Core Operating Limits Report

LaSalle County Station

Unit 2, Reload 4 (Cycle 5)

ISSUANCE OF CHANGES SUMMARY

MCPR versus Tau at ICF and FFWTR
Figure 2.2-1

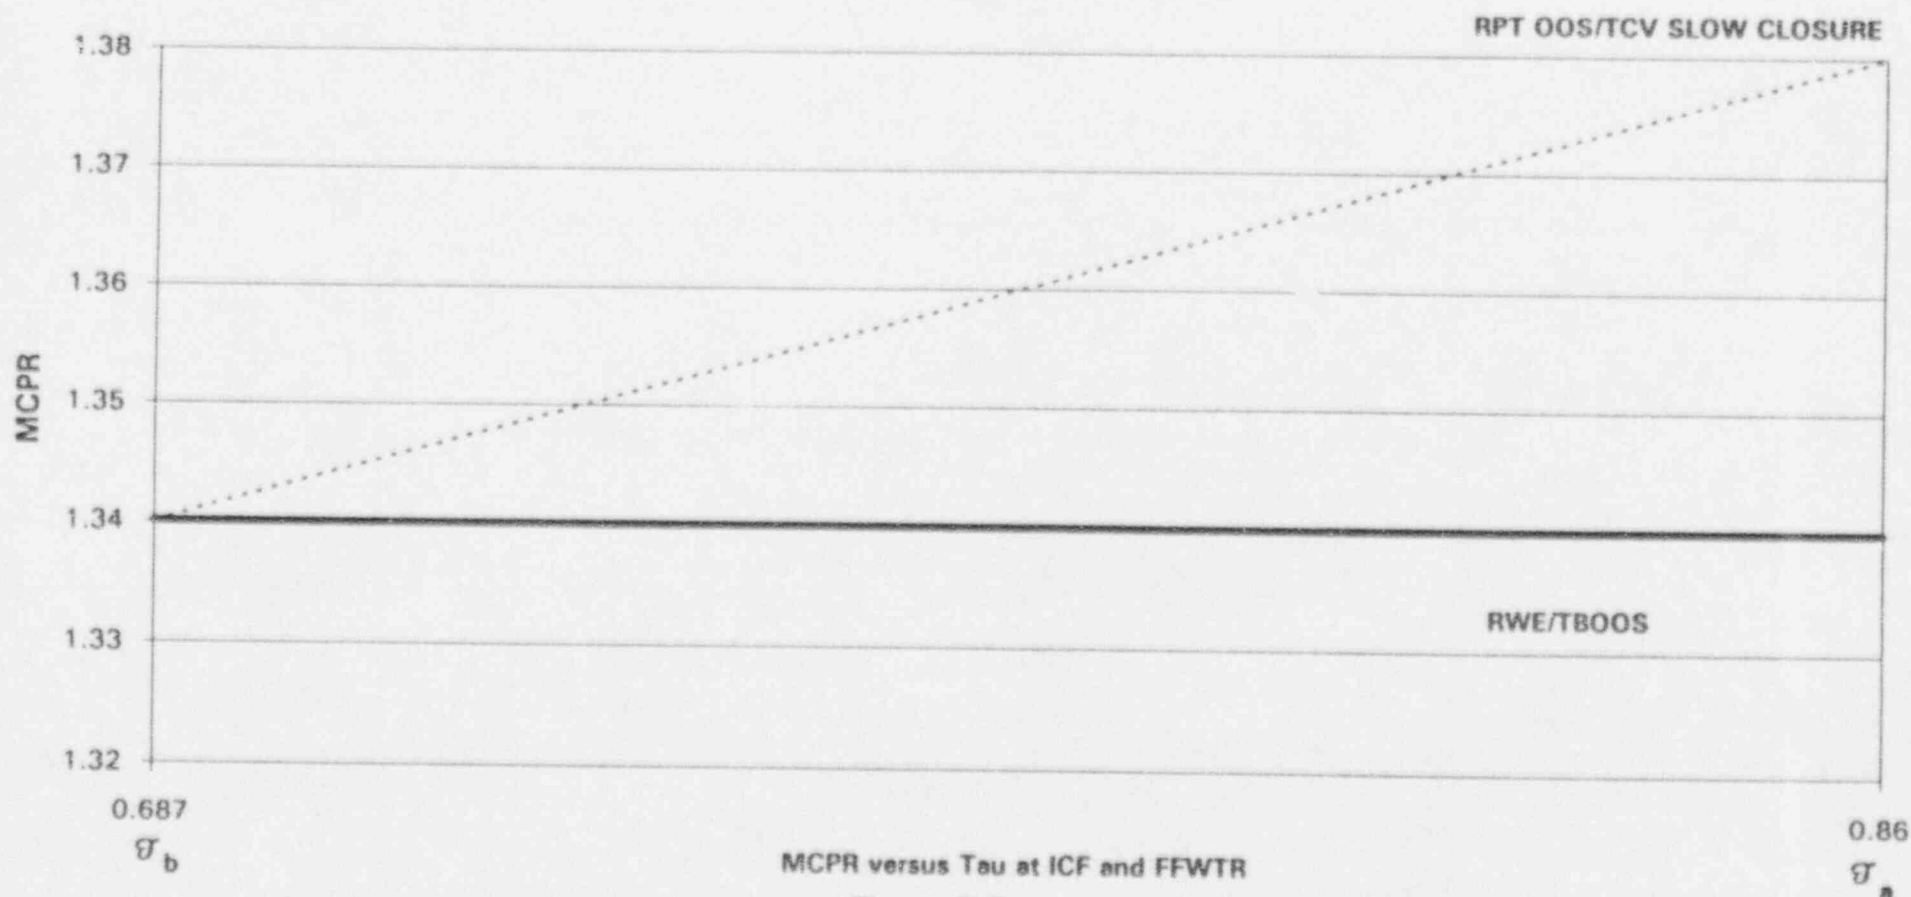
Affected Section	Affected Pages	Summary of Changes	Date
All	All	Original Issue (Cycle 4)	4/90
All	All	Original Issue (Cycle 5)	3/92
2.0	2-2	Revised NCPR Power Distribution Limits (all fuel types) for New TCV Analysis Slow Closure Event	6/93
2.0	2-4	MCPR Power Distribution Limits (all fuel types) for Coastdown Analysis	6/93

The MCPR limit when in Dual Recirculation Loop Operation with the End-of-Cycle Recirculation Pump Trip System (RPT) Inoperable (per Tech Spec 3.3.4.2) and/or one or more Turbine Control Valve Slow Closing is determined from Figure 2.2-1* times the Kf factor determined from Figure 2.2-2.

Figure 2.2-3

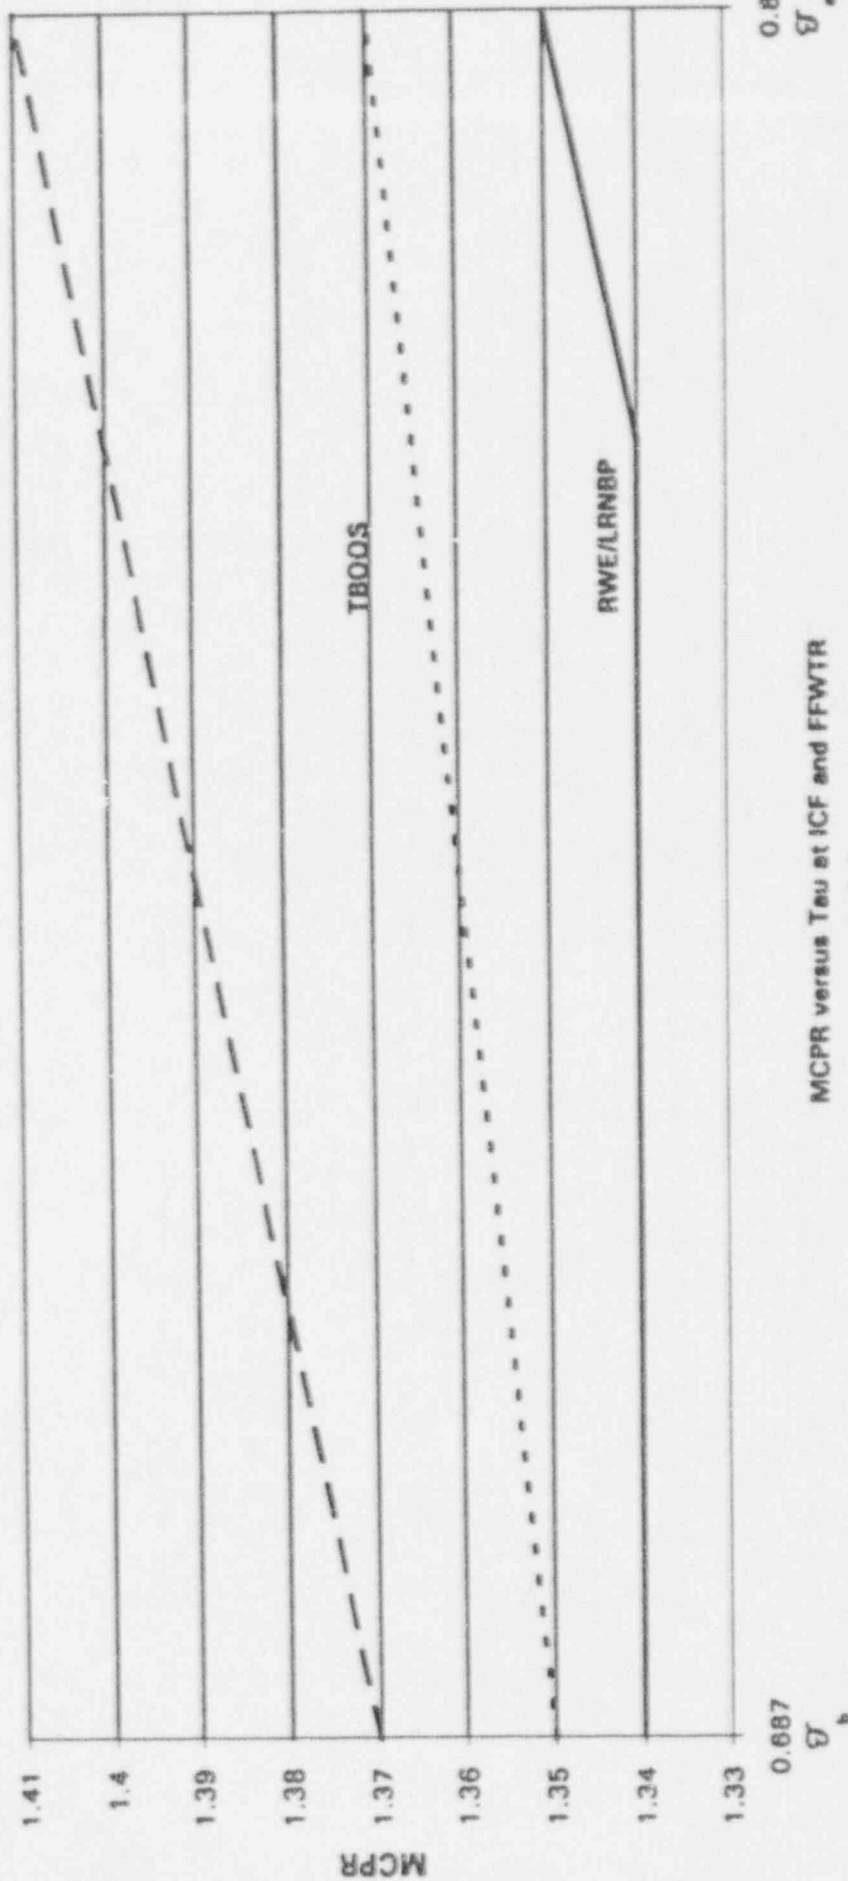
- * If, during Unit Coastdown, power operation exceeding the equilibrium power level is desired, then Figure 2.2-3 shall be used.
